TRANSPORT ASSESSMENT ADDENDUM

Land at M40 Junction 10

LPA References 21/03266/F, 21/03267/OUT and 21/03268/OUT

Job No:	17213
Report Number:	17e
Status:	Final
Prepared By:	RM
Date:	03/05/24
Checked By:	SKP
Date:	03/05/24

Public rights of way

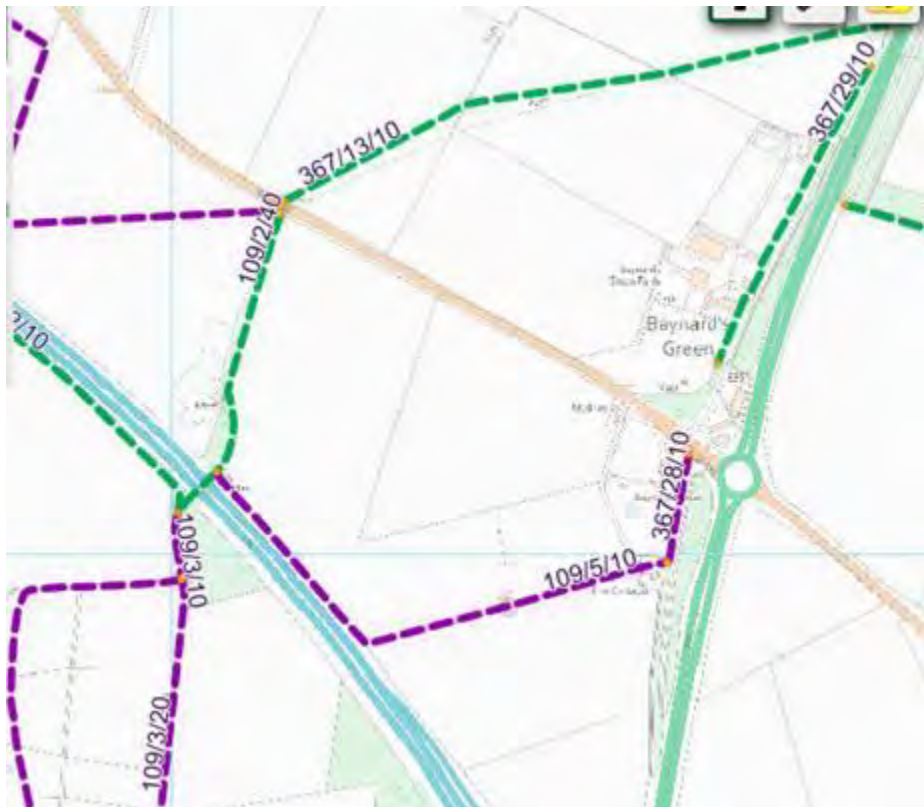
Footpath 109/5/10 is proposed to be diverted as it passes through the site. OCC would like to see this dedicated as a bridleway at the same time as any diversion, which would allow for cycling, and complete a missing link between Stoke Lyne Bridleway 367/29 and Ardley Bridleway 109/2. This could be a 3m wide tarmac path with a verge on either side. See map and annotations below. This comment is made without prejudice to the desirability/outcome of any application to divert PRow. The existing/altered footpath connection to opposite the services should be retained.

The preferred alignment would be as shown below, and make use of the 3m wide cycle connection to the site, although as stated above, it would be better within the site rather than alongside the B4100. An improved crossing point leading across the B4100 into the service area site, would provide an onward connection to bridleway 367/29. As the area of highway land on the western side of the service area access is quite wide, it should be separated from the access road by a verge until it can connect with the access road at a safe point.
